Agenda
Lane Cove Local Planning Panel Meeting
21 June 2023

Lane Cove Local Planning Panel Meeting 21 June 2023
13-19 CANBERRA AVENUE, ST LEONARDS

Subject: 13-19 Canberra Avenue, St Leonards
Record No: DA23/21-01 - 28343/23
Division: Environmental Services Division
Author(s): Greg Samardzic

DA Number	21/2023
LGA	Lane Cove Council
Proposed Development	Alterations and additions to an approved mixed-use development
Street Address	Nos. 13 to 19 Canberra Avenue, St Leonards
Applicant/Owner	Applicant: Simon Truong - HPG General P/L Owners: SLD P/L
Date of DA lodgement	13 March 2023
Total number of Submissions	14
Number of Unique Objections	14
Recommendation	Refusal
Local Planning Panel Referral Criteria (Schedule 1 of Planning Direction)	<p>Contentious Development: More than 10 unique submissions have been received by way of objection; and</p> <p>Departure from Development Standards: Development that contravenes development standards imposed by an environmental planning instrument by more than 10%.</p>
List of all relevant s4.15(1)(a) matters	<ul style="list-style-type: none"> • relevant environmental planning instruments SEPP 65 – Design Quality of Residential Apartment Development; S

Figure 12: DRP – 2.5m Western Setback Recommendation

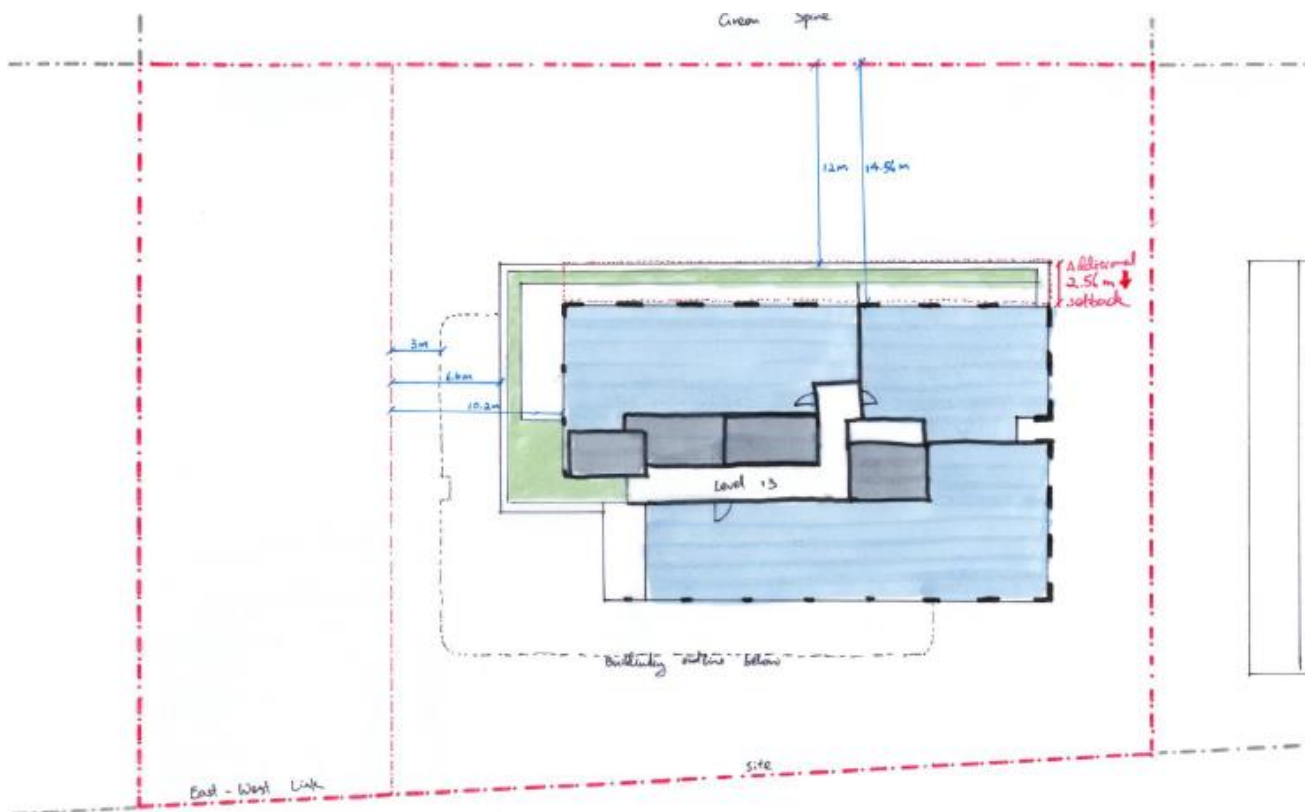
No formal design amendments had occurred however the applicant had indicated that the following design amendment would occur to address part of the Design Review Panel (DRP) concerns with the proposal as follows:

Note: Should the above design had been formally submitted, the proposal would have still been recommended for refusal due to the breaches in height and number of storeys.

Figure 15: Proposed Breach to the Maximum 44m Building Height Plane

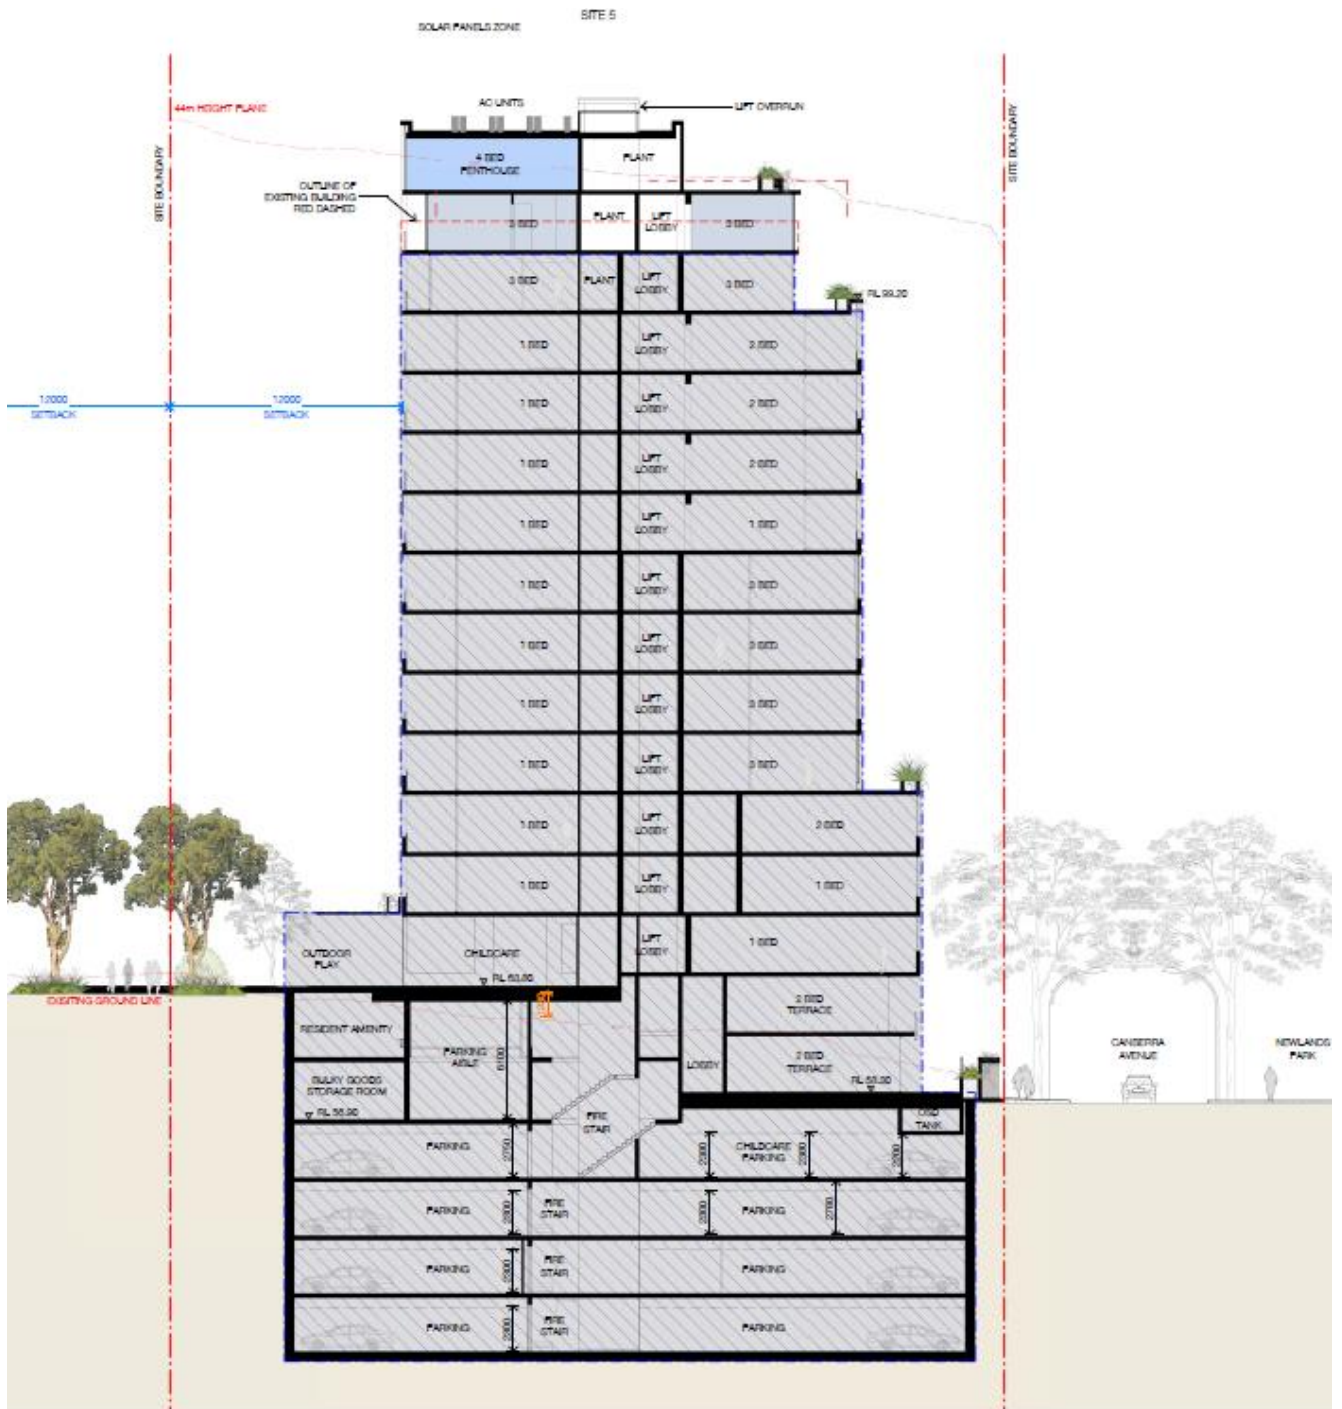
The proposed variation would result in additional adverse visual impacts and unnecessary bulk or scale to surrounding developments and strict compliance is reasonable in this instance. The development as amended would not present as an appropriate built form outcome for the new precinct. There are proposed units that sit above the maximum building height plane and the proposed variation would have additional adverse impacts onto the immediate locality. The variation is not consistent with the objectives of the development standard for the following reasons:

- The proposed variation provides for additional bulk and scale of the development and would allow for additional overshadowing to adjoining buildings and public areas.
- The proposal does not contain additional adverse privacy and visual impacts on neighbouring properties and on the adjoining green spine/east-west pedestrian link.

Figure 21 – Proposed 14 Storey Building

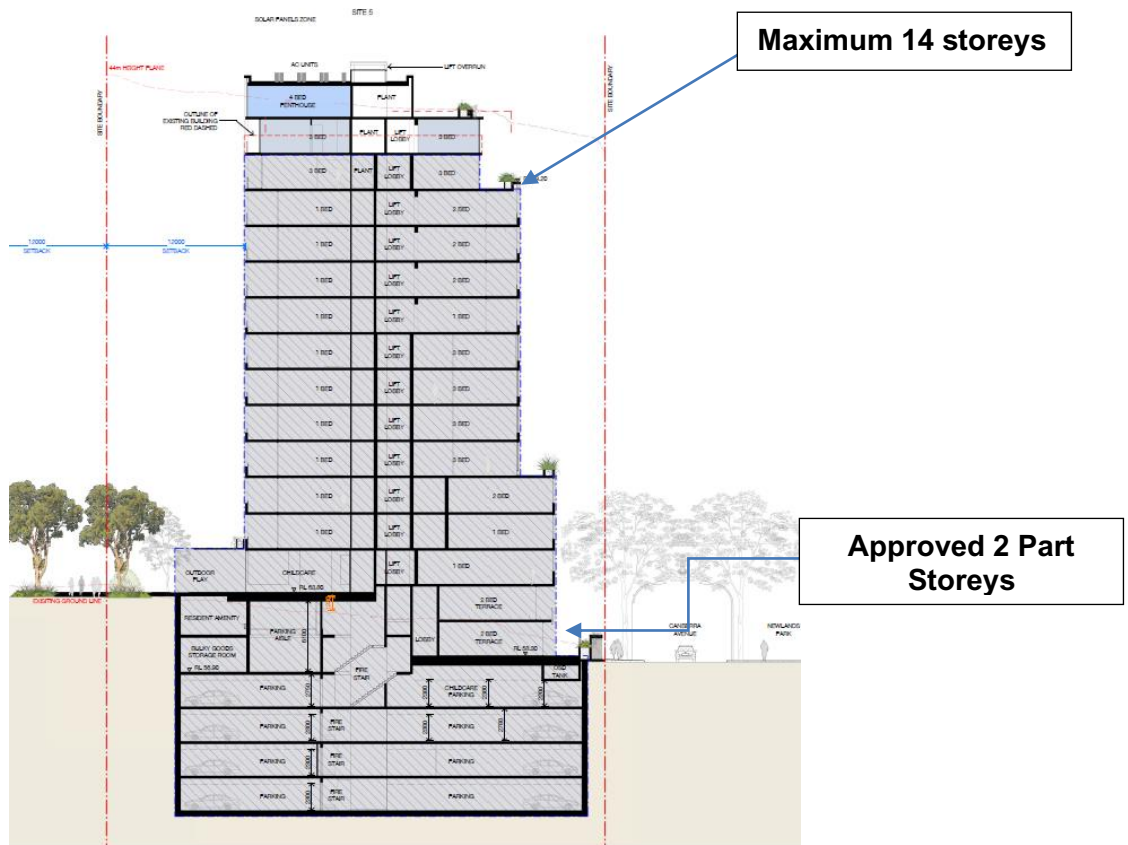
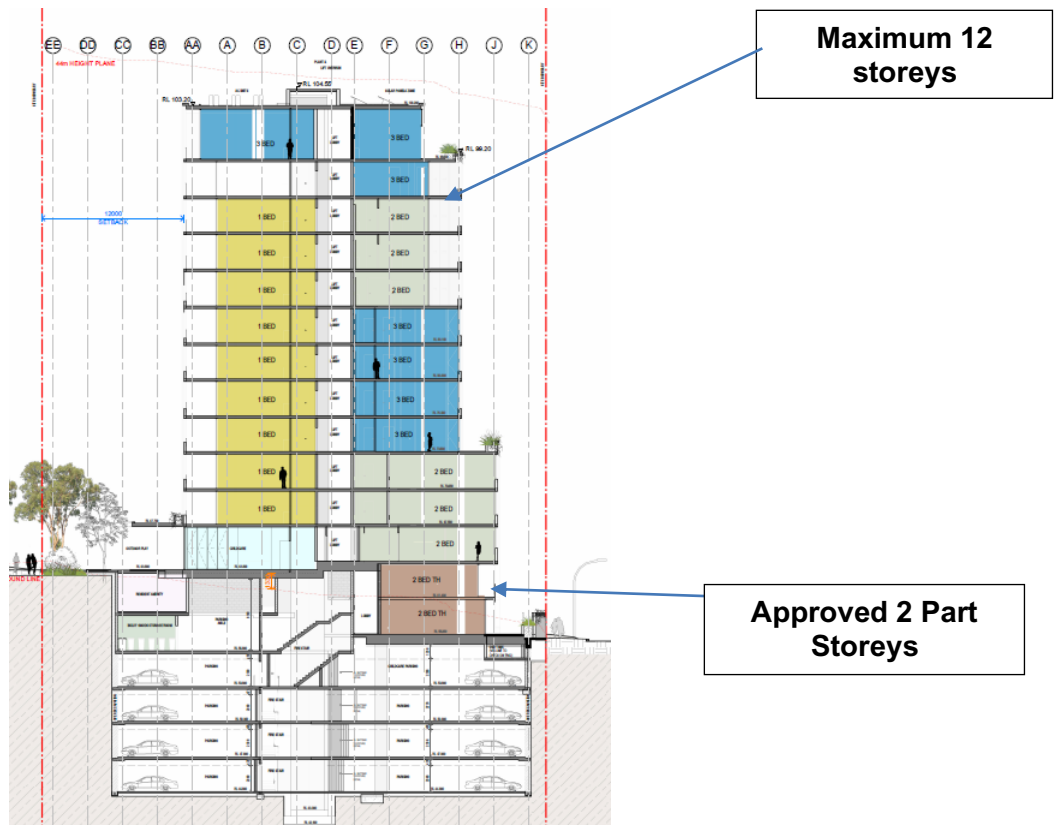
Based on the relevant 'part storey' definitions described above in this report and the maximum 12 storeys control, it is considered that the proposal does not comply with the relevant number of storeys DCP controls.

A **maximum of 14 storeys** is now proposed.

The applicant has been advised that support for the proposed variation to the number of storeys would not be supported with a likely recommendation for refusal. The applicant is still seeking determination of the subject application and has provided the following justification:
